ref.15186.JBH

RE: NORTHLAND REGIONAL COUNCIL – AWANUI FLOOD SCHEME UPGRADE – ADDENDUM TO APPLICATION

Please take this letter as an addendum to the application recently lodged for approval with both the Northland Regional Council and Far North District Council (referenced APP.042075.01.01 (NRC) and 2300056-RMALUC (FNDC)).

Figure 1: Proposed new works:

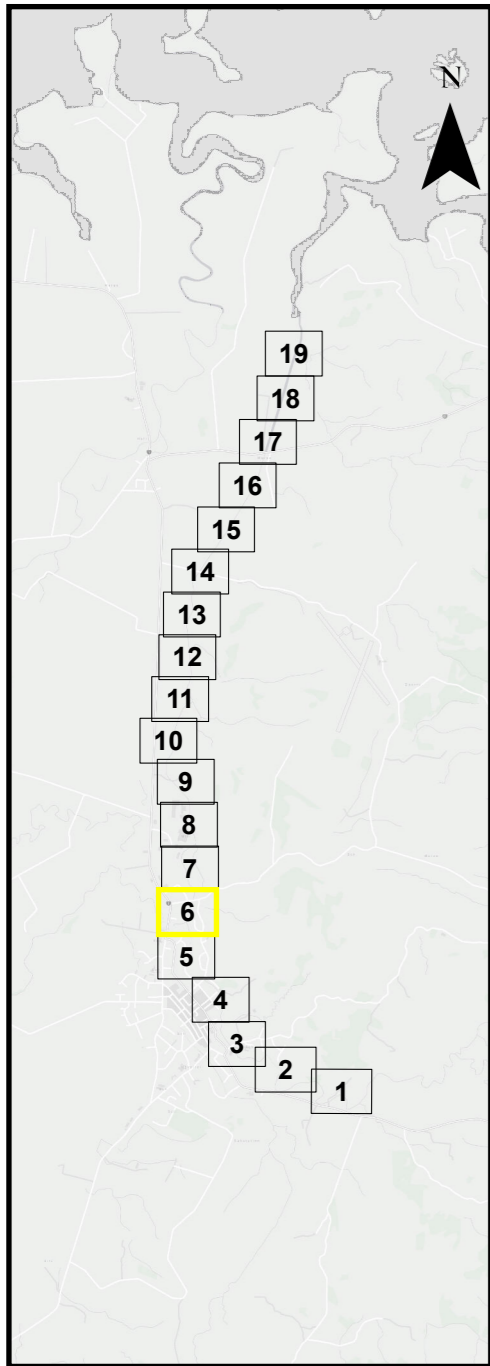
- Additional flood protection works are proposed to be undertaken as shown on the amended scheme design plan attached, and in Figure 1 below:

The purpose of these works is to provide additional protection for Northpark development to the north (and surrounding residential and commercial activities). The above works will take place within the following allotments:
